ADDENDUM # 1 SOLICITATION RFP # 2019-17

Calhoun Street Bulkhead

This addendum is being issued to provide question and answers, and provide a tree topo drawing and a revised bid sheet.

In addition to Q&A, there is one new drawing, RFP 2019-17 Tree Topo, and an updated bid sheet included with this addendum.

BOUNDARY, ASBUILT
 TREE & TOPOGRAPHIC
 SURVEY OF THE
SQUIRE POPE CARRIAGE HOUSE
#111 CALHOUN STREET
 THE TOWN OF BLUFFTON, BEAUFORT COUNTY, SOUTH CAROLINA
 SCALE: 1" = 20' DATE: 04/12/2017 JOB NO: SC170047

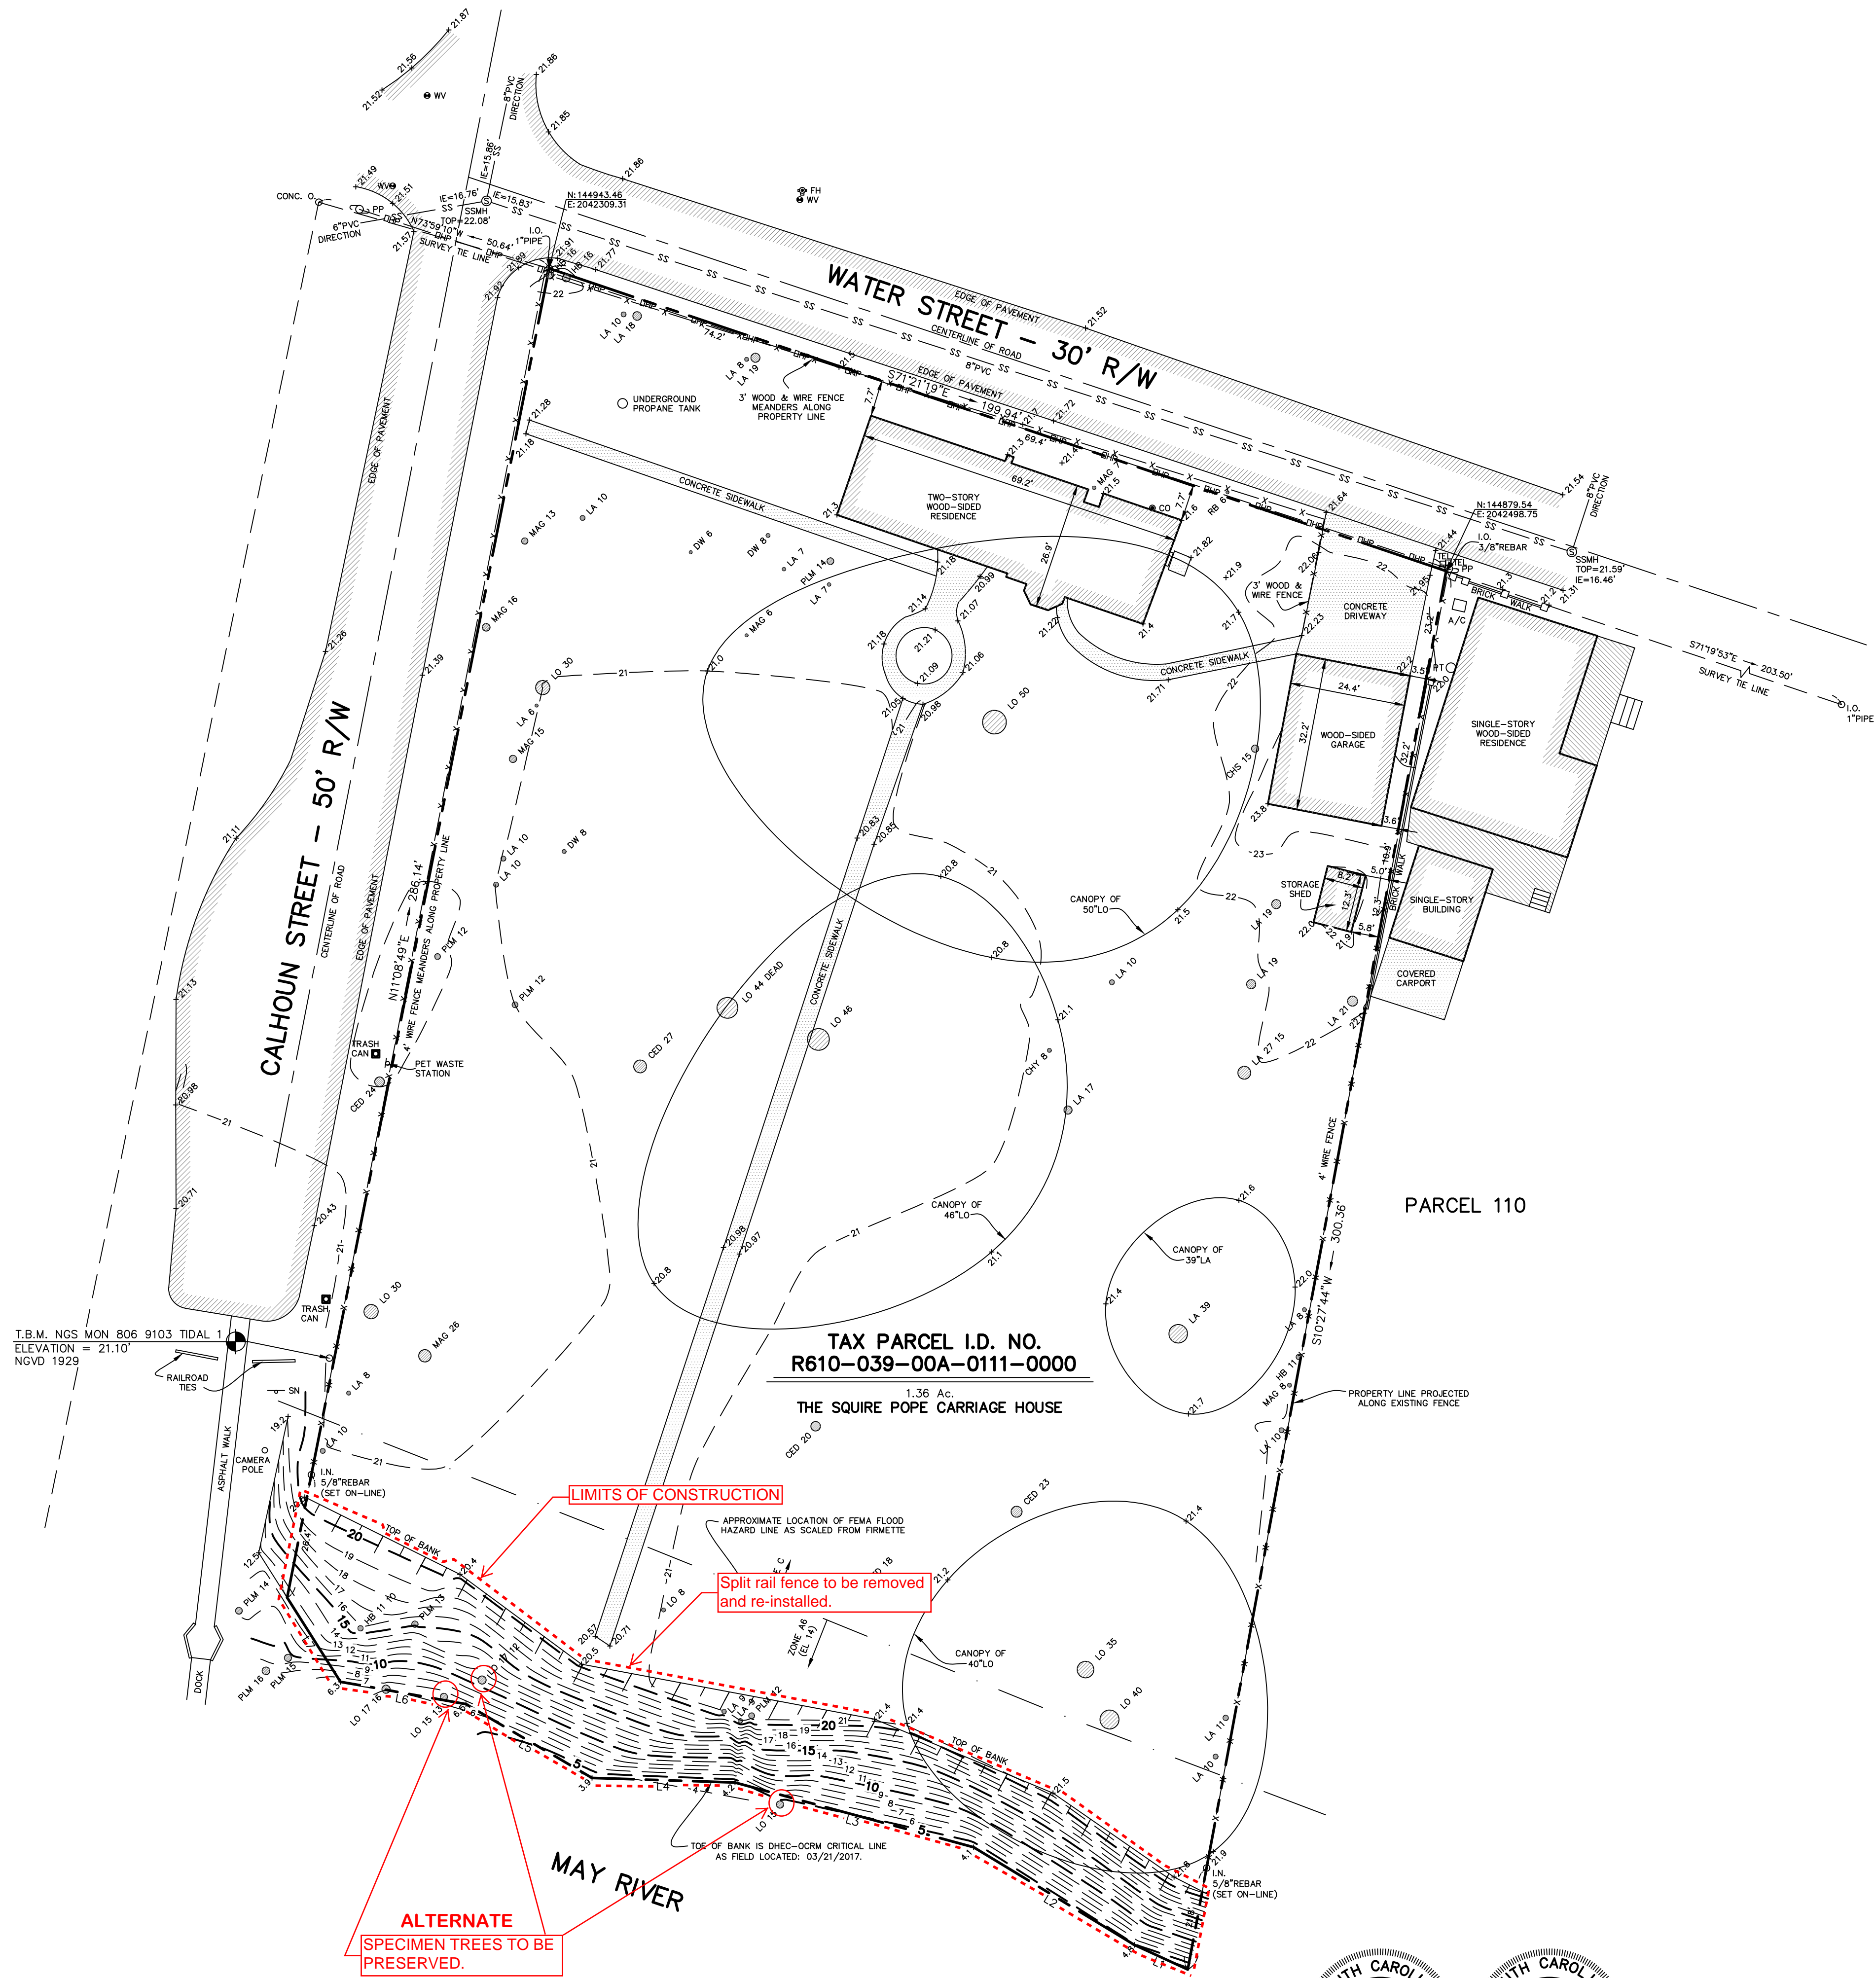
1. Please indicate if the four (4) trees pointed out during the pre-bid must be saved. The trees will become a detriment to the new wall and should be removed to guarantee long-term structural stability of the new wall. **See attached sketch indicating the trees to be preserved as an Alternate. The base bid should be presented as per the permits which calls for the continuous bulkhead with the trees removed. An Alternate bid should be presented preserving three (3) trees (LO 15 13, LO 17 12 & LO 15).**

9. At the pre-bid it was stated that part of the contract is to protect and work around four existing trees on the bank. Has the Town confirmed there are no conflicts (either vertically or horizontally) with the permitted wall location and the trees? If there are conflicts, what

10. Can the Town provide a plan drawing (not written description) showing the limits of disturbance which the contractor must contain the construction? Yes, see drawing attached to this addendum.

- 17. Are there liquidated damaged associated with going past the end of construction date? **Yes, \$500 per day.**
- 18. Is there existing Geo-technical data of the bulkhead area? **No, there is a line item for geotechnical testing in the bid tab.**
- 19. Is there a survey/tree topo that the town can provide? **Yes, the town has a topographical survey that will be included in this addendum.**
- 20. Will the town consider all steel bulkhead or all rip-rap along critical line? **No. The bulkhead material should be wood to blend into the bulkheads on adjacent properties.**

direction can the Town give the bidders as far as anticipated resolution so we can account for this in the bid? There are definitely conflicts with the proposed bulkhead and trees suggested to be preserved. The trees would have to be removed if a continuous bulkhead is installed as required in the base bid. An alternate bid item is provided in the RFP that suggests that the bulkhead stop on either side of the two tree cluster areas, tie back into the slope with wing walls and creating a tree preservation zone on the seaward side of the embankment. At these tree preservation areas, rip rap and filter fabric would be required to infill between the adjacent wing walls to create a continuous shoreline protection structure between bulkhead sections. It is the Town's understanding that it is not uncommon that after inspection, OCRM may permit this type of modification as a field change in order to accommodate specimen trees. If the Alternate is selected, then engineering/permitting review costs should be included in the Alternate bid item.
